From: WELLS Russell (AREVA) [Russell.Wells@areva.com]
Sent: Friday, July 29, 2011 5:28 PM
To: Tesfaye, Getachew
Cc: ROMINE Judy (AREVA); KOWALSKI David (AREVA); WILLIFORD Dennis (AREVA); BENNETT Kathy (AREVA); DELANO Karen (AREVA); RYAN Tom (AREVA)
Subject: Response to U.S. EPR Design Certification Application RAI No. 482 (5611), FSAR Ch. 9, Supplement 1
Attachments: RAI 482 Supplement 1 Response US EPR DC.pdf

Request for Additional Information No. 482(5611), Supplement 1

U.S. EPR Standard Design Certification

SRP Section: 09.05.01 - Fire Protection Program

Figure 9.5.1-1—Fire Water Distribution System
Sheet 1 of 13

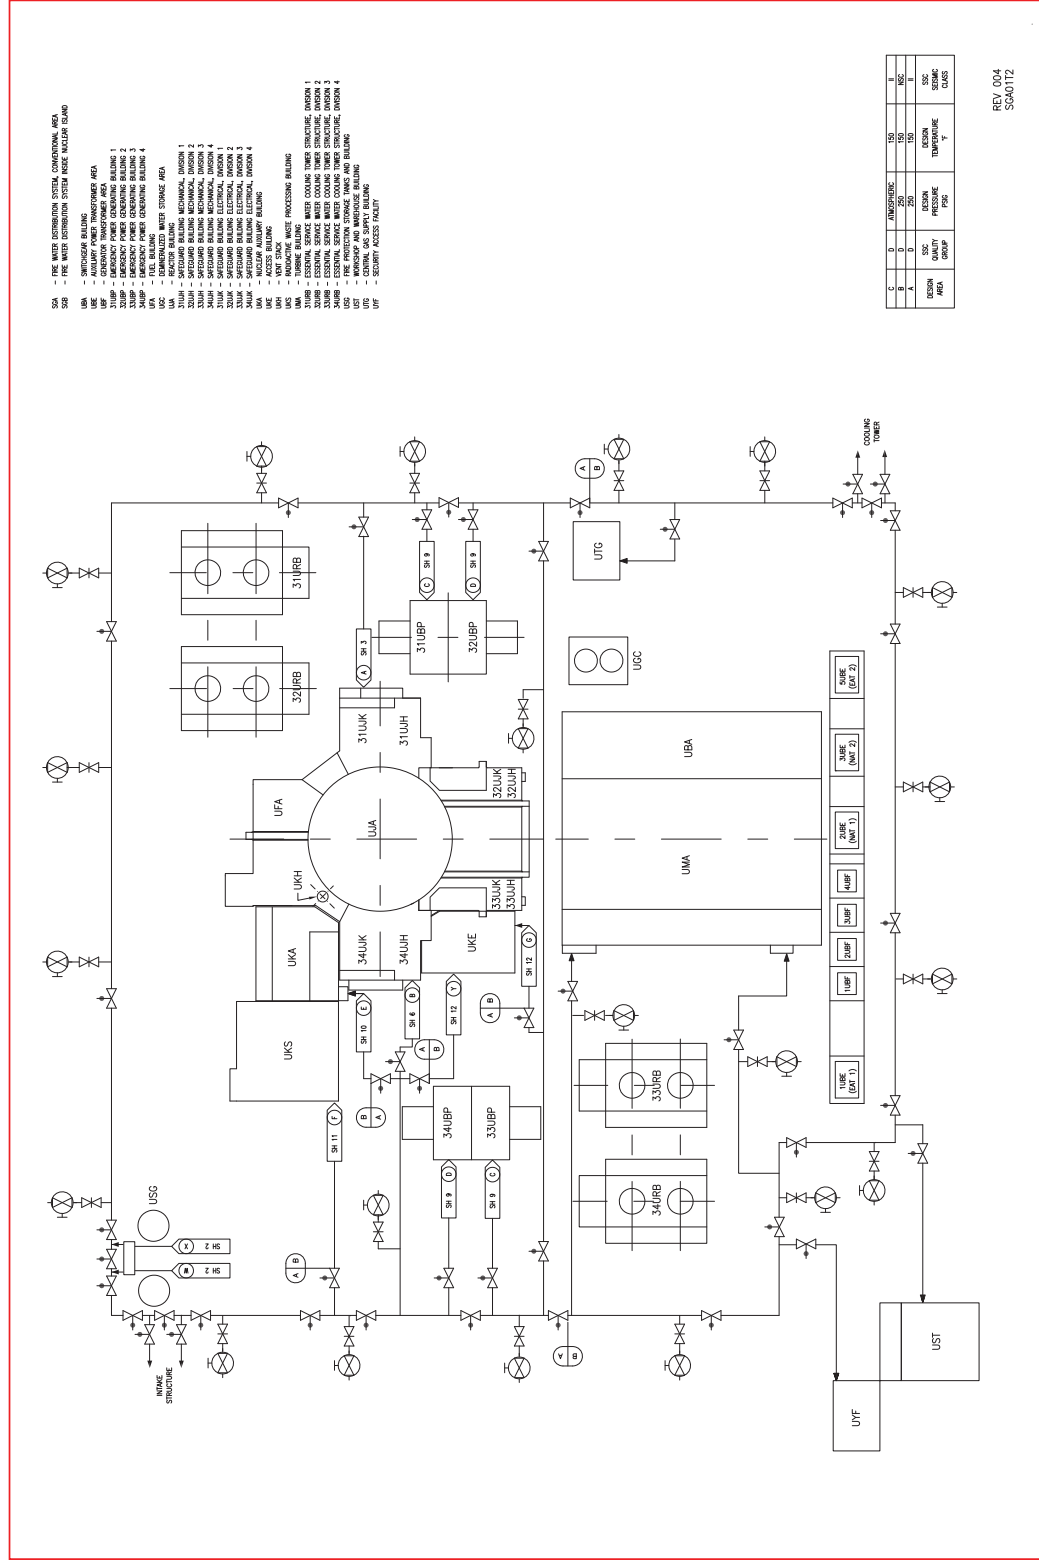
U.S. EPR FSAR Revision 2 Figure 9.5.1-1, Fire Water Distribution System, Sheets 4, 7, 8, and 13 have drawing errors. Sheet 4 shows that point "T" connects to Sheet 11 but it should connect to sheet 13. Sheet 7 shows that point "P" connects to Sheet 11 but it should connect to sheet 13 and that point "R" connects to Sheet 6 but it should connect to Sheet 8. Sheet 8 shows that point "R" connects to Sheet 5 but it should connect to Sheet 7. Sheet 13 shows that point "T" connects to Sheet 2 but it should connect to sheet 4 and that point "P" connects to Sheet 5 but it should connect to sheet 7. The applicant needs to revise Figure 9.5.1-1 as per above and review Figure 9.5.1-1 for any other discrepancies and revise as needed.

U.S. EPR FSAR Tier 2, Figure 9.5.1-1—Fire Water Distribution System, Sheets 1 through 13, have been reviewed for discrepancies. Sheets 1, 3, and 4 through 13 of this figure will be revised to remove existing discrepancies from fire water distribution system drawings.

RAI 482
Q. 09.05.01-82
